Pacific Attires Limited

Plot No. # 09-13 and Adjacent to Plot No. # 13, Sector # 05, Chattogram EPZ.
(22.29569012509762, 91.77564570719528)

18 May 2025

Observation-2: Discrepancies and incomplete as-built drawings (Factory Building).

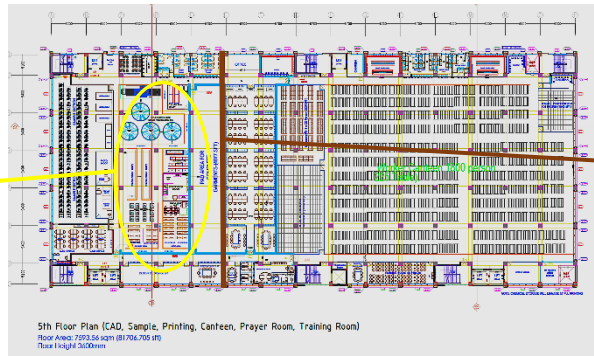
Dining area instead of Printing at 5th floor

10-inch brick partition at all floor except GF.

Void area at 1st to 7th floor.

Description: During the inspection, discrepancies were observed between the as-built drawing and the on-site condition. 10-inch brick partition wall on all floors except the ground floor, not shown in the as-built drawing. The void area (from the 1st to the 7th floor) is not shown in all the layout plans. The building engineer is required to survey the whole structure and update the as-built drawings reflecting the on-site conditions.
